Instructions modification Hot-start device Rev-3 4T

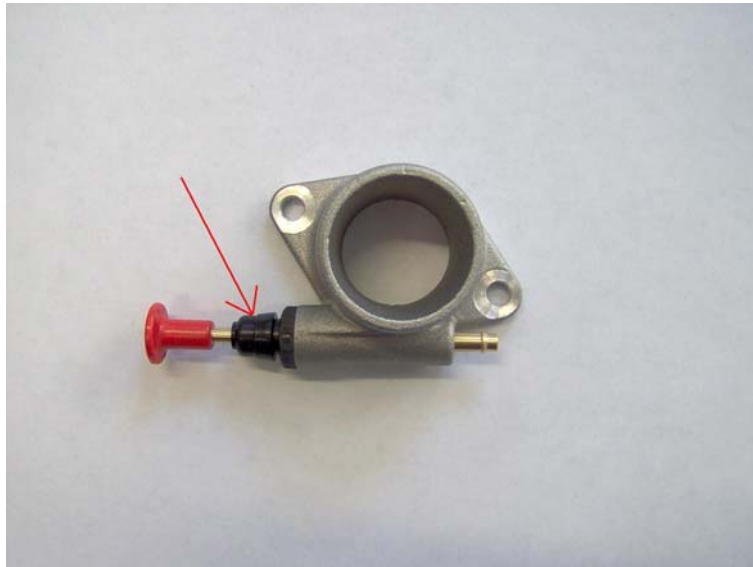
On the standard bike the hot start does not work so well. With this modification it makes the 4T much easier to start when it will not start normally:

1. Remove the carburettor manifold
2. Remove the Hot-start knob

3. Widen the calibrated hole to Ø2mm

4. Deeply clean the part and assemble again
